31/6 Prelim. 10415 Armory Avenue 193
(Kensington Historic District)

HISTORIC PRESERVATION COMMISSION STAFF REPORT

Address: 10415 Armory Avenue	Meeting Date: 9/22/93
Resource: Kensington Historic District	Preliminary Consultation
Case Number: n/a	Tax Credit: No
Public Notice: 9/8/93	Report Date: 9/16/93
Applicant: George T. Myers	Staff: Nancy Witherell
PROPOSAL: Rear addition	RECOMMEND: Further study

**PROPOSED ADDITION
TO
10415 ARMORY AVENUE**

APPROVED SCHEMATIC
SITE DEVELOPMENT
PLAN - 1991

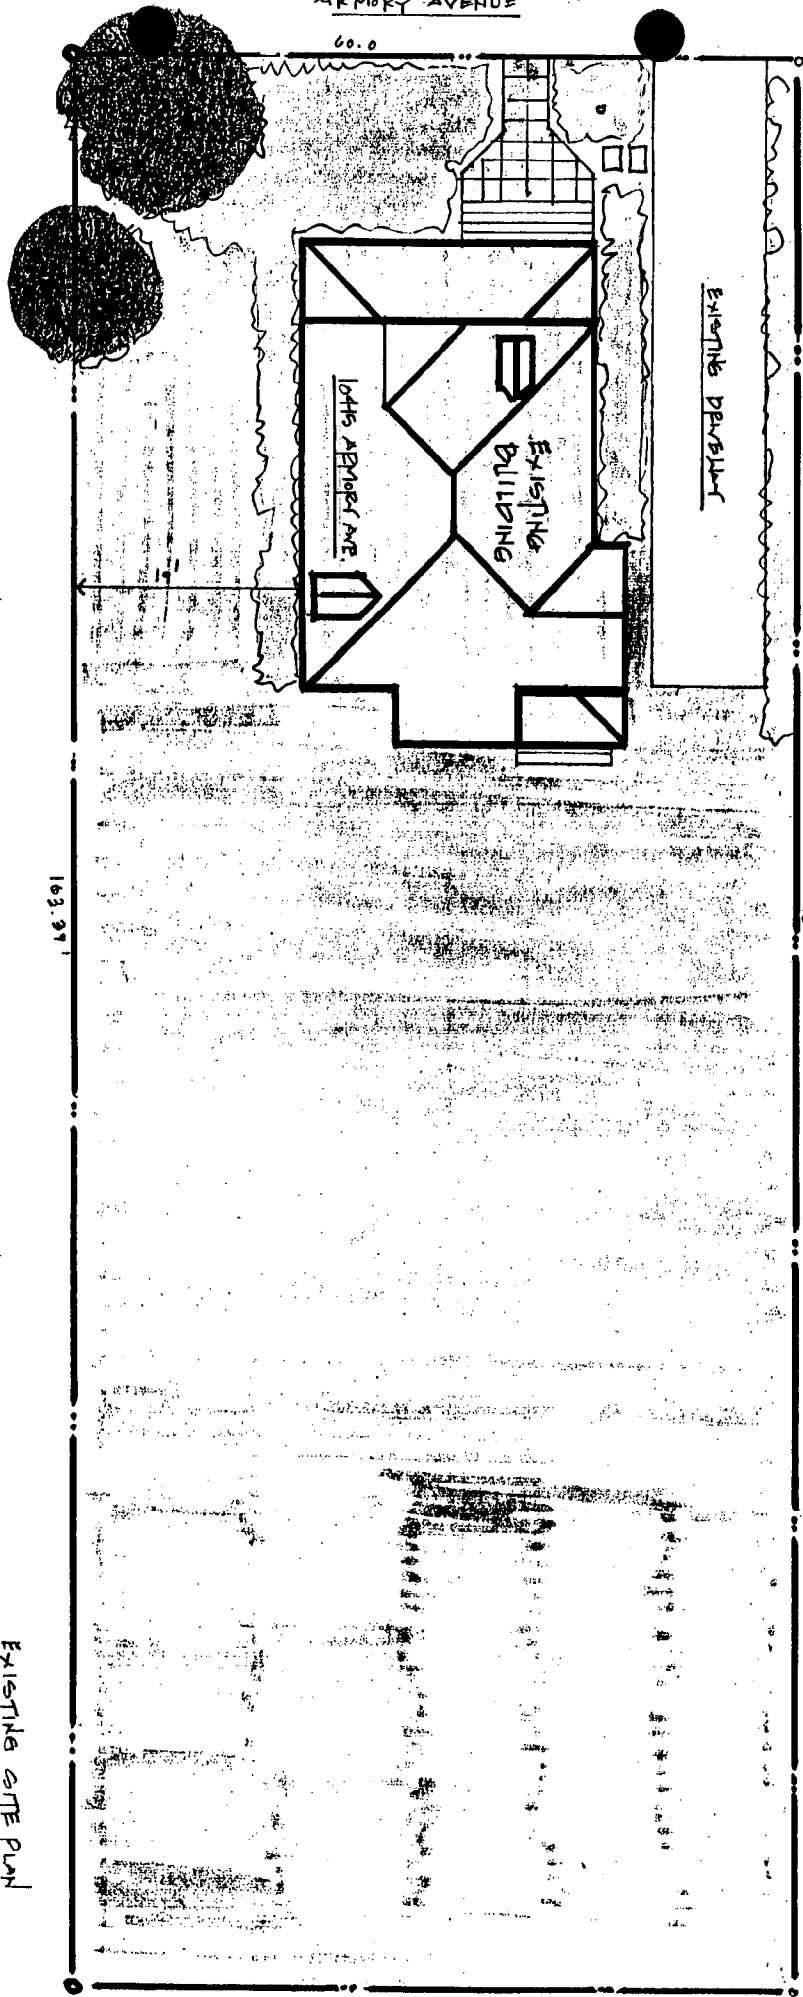
The applicant has submitted on page 3 of the packet the schematic site plan approved in 1991. It includes 7 parking spaces accessed by two driveways. Although some areas of greenspace would be preserved, the house would be virtually surrounded by paving when seen from the street. Pages 5 and 6 show, in two phases, the site plan the applicant would propose if an addition were approved by the HPC. In both schemes, only one driveway is proposed, thus saving greenspace at the front of the lot.

PROPOSED SITE PLAN
PHASE ONE: PARTIAL
RESIDENTIAL
USE

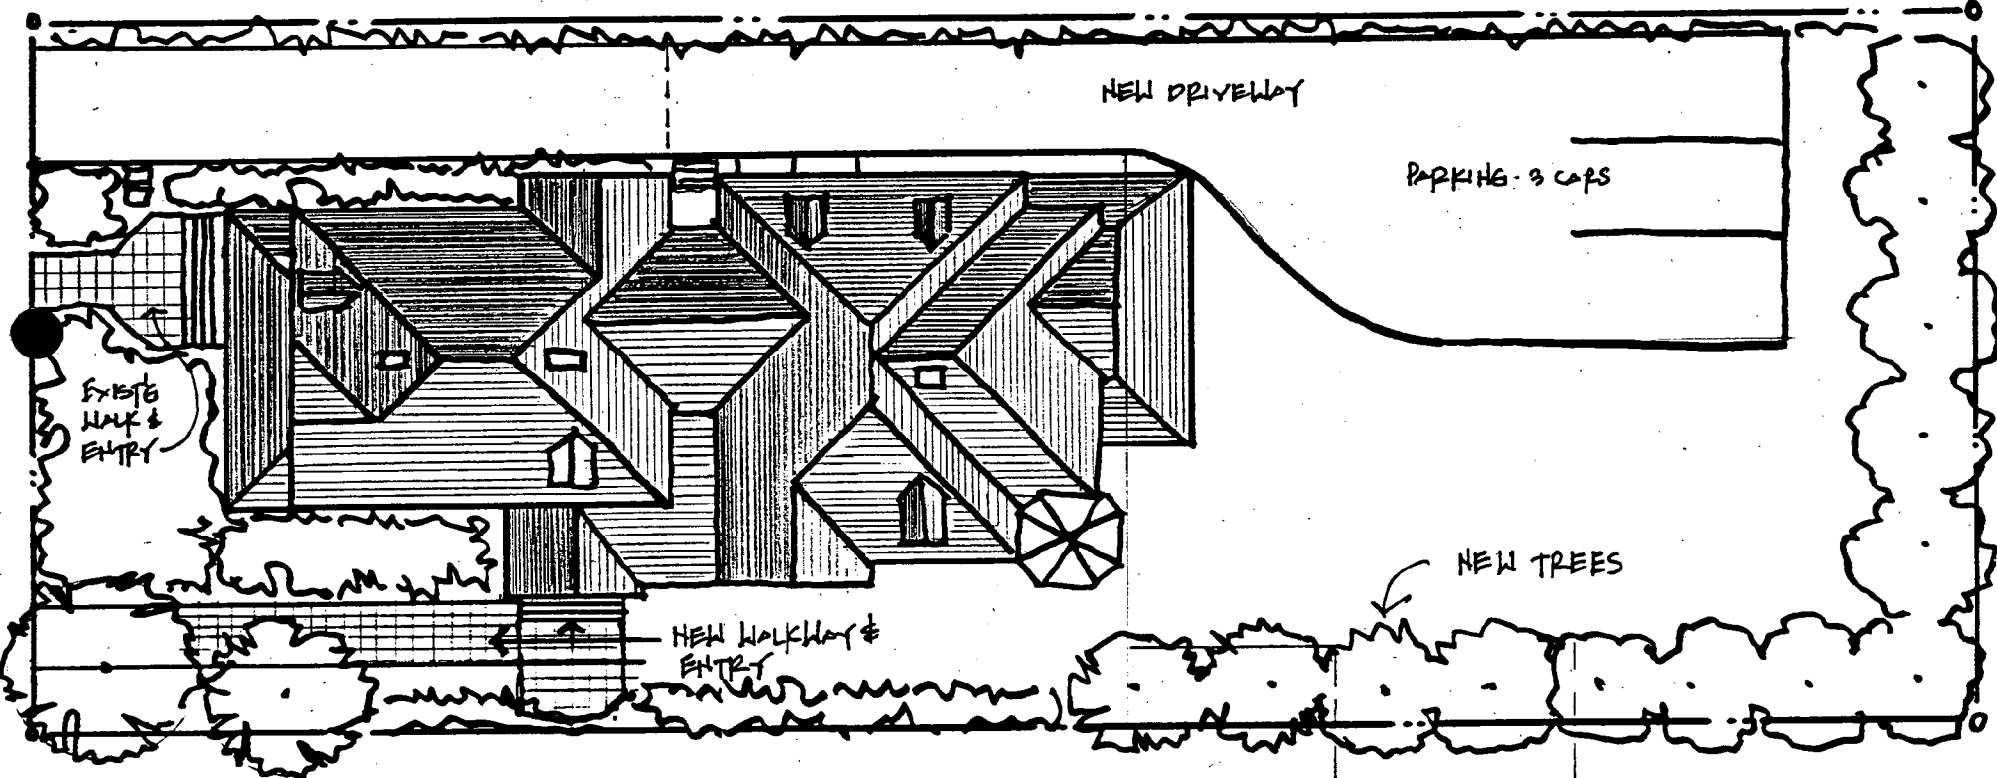
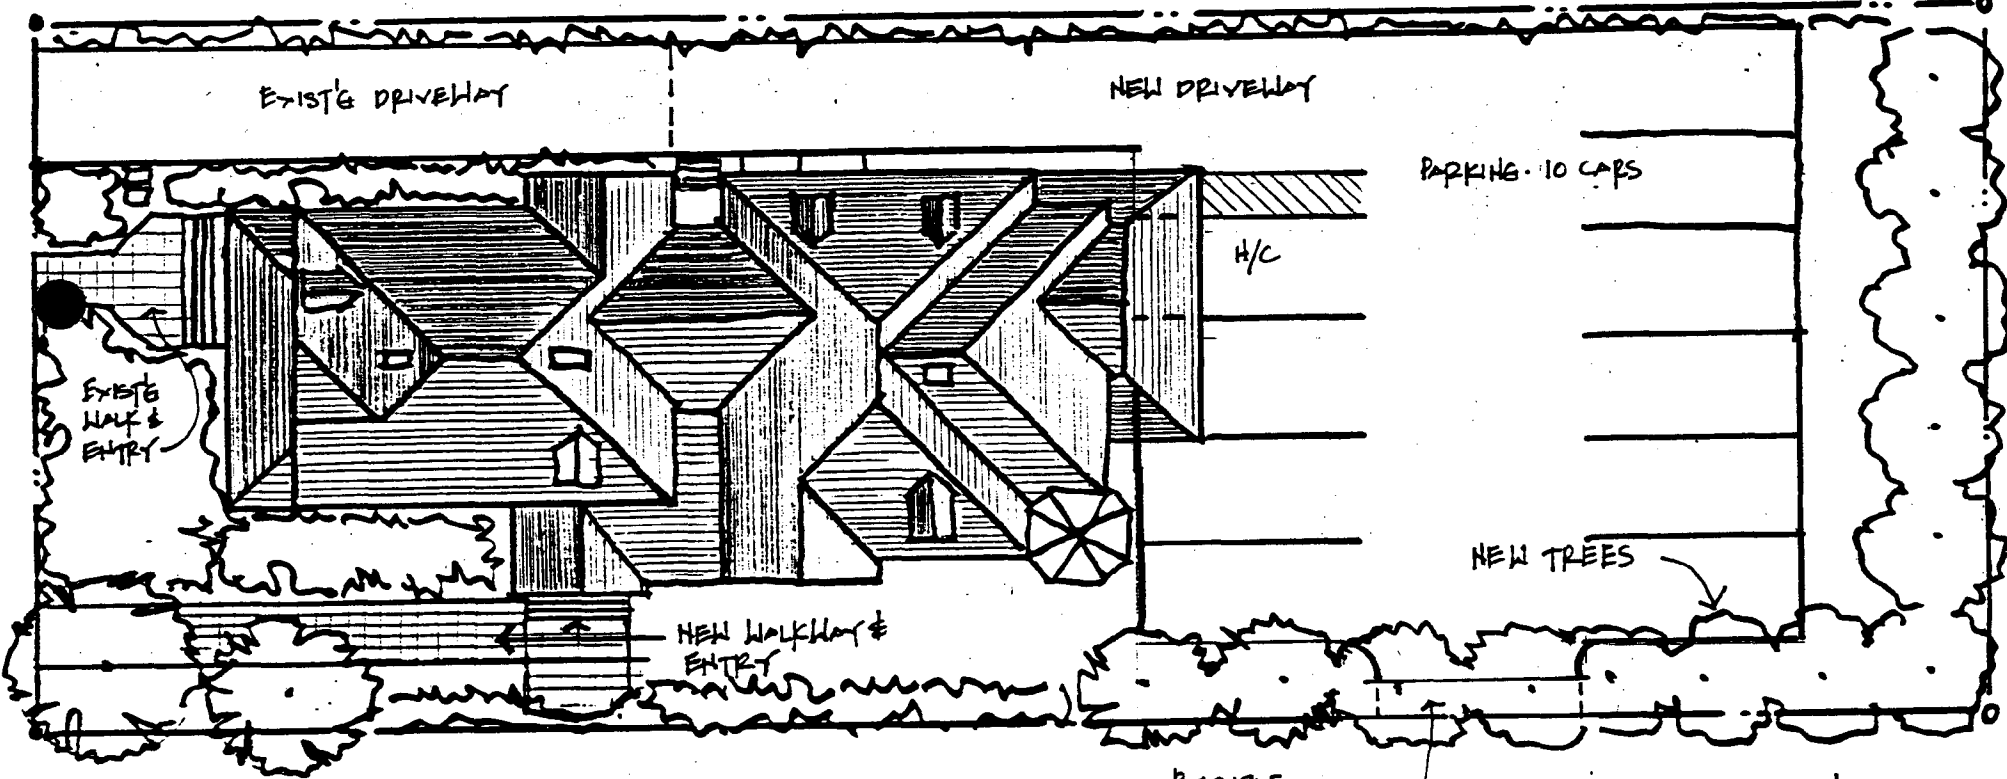
The staff notes, however, that the proposed site plan on page 6 shows the addition extending all the way to the paved parking lot. The absence of appropriate greenspace directly behind the structure--so that the building can continue to read as a historic residential structure--reinforces the staff's recommendation that the addition be made smaller and more sympathetic to the scale of the existing primary resource.

SIDE (SOUTH) ELEVATION
FACILE CHURCH - OPTION #1

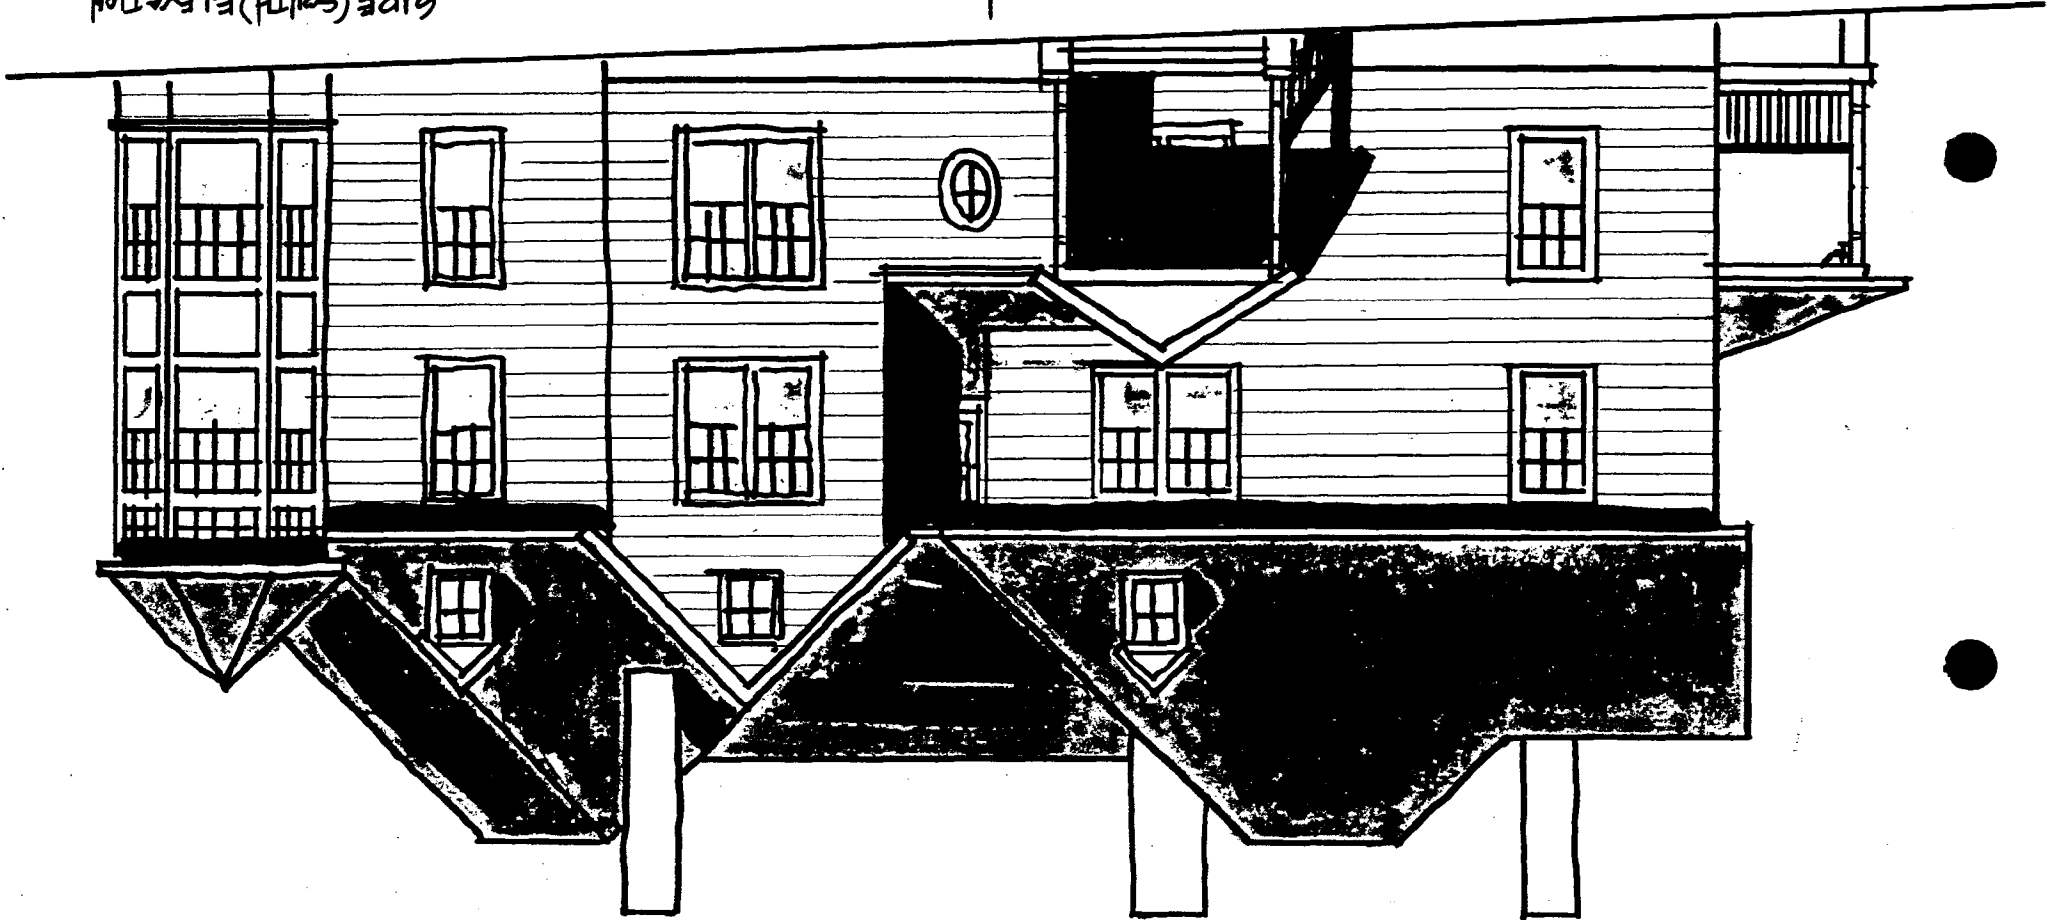
The applicant has submitted two schemes, the first of which integrates a side porch on the south elevation with the existing front porch, and a longer one-story section on the north elevation. The second scheme leaves the front porch intact and utilizes a small entrance porch on the south elevation, instead. In addition, the north elevation features a smaller porch and a projecting bay.

The staff would suggest, however, that a smaller addition could be constructed behind the existing house. The rear elevation is fairly flat and a well-articulated addition could be attached to it without distorting the architectural character of the building. The addition, if shorter, would solve the problem inherent in this proposal, particularly in scheme 1, of apparent bisymmetry on the north elevation. In general, the staff would recommend the approach shown in scheme 2, which keeps the original front porch separate from the new entrance on the side (south) elevation.

SIDE (NORTH) ELEVATION
OPTION #1

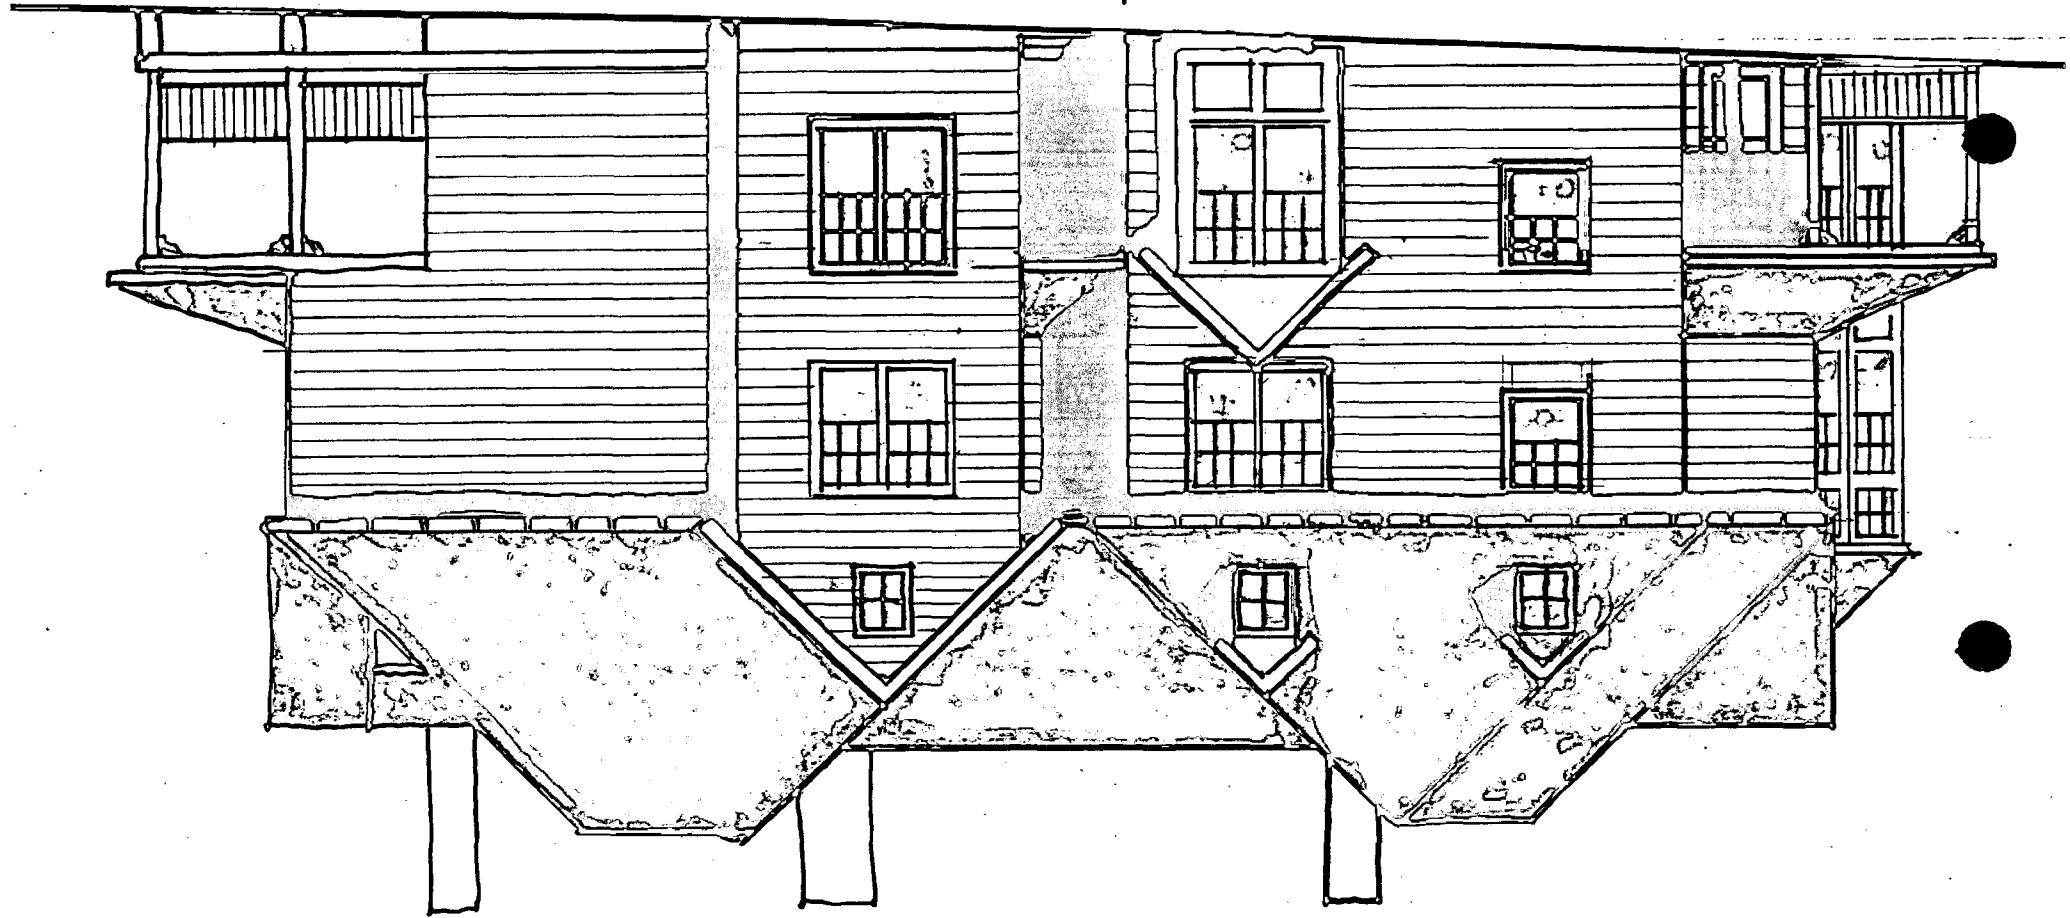
Constructing an addition on this structure would meet the purposes of Chapter 24A and be consistent with approved rear additions to primary resources in the Kensington Historic District. However, in the staff's judgment, the proposed addition is too large for the building. Although the addition's massing has been fairly well articulated, it would create, if built, a structure fundamentally different than the existing structure. Instead of a house that is fairly square in plan and organized under a hip roof, the structure would become a very long rectangle, with a length and massing that did not occur in houses of the period.
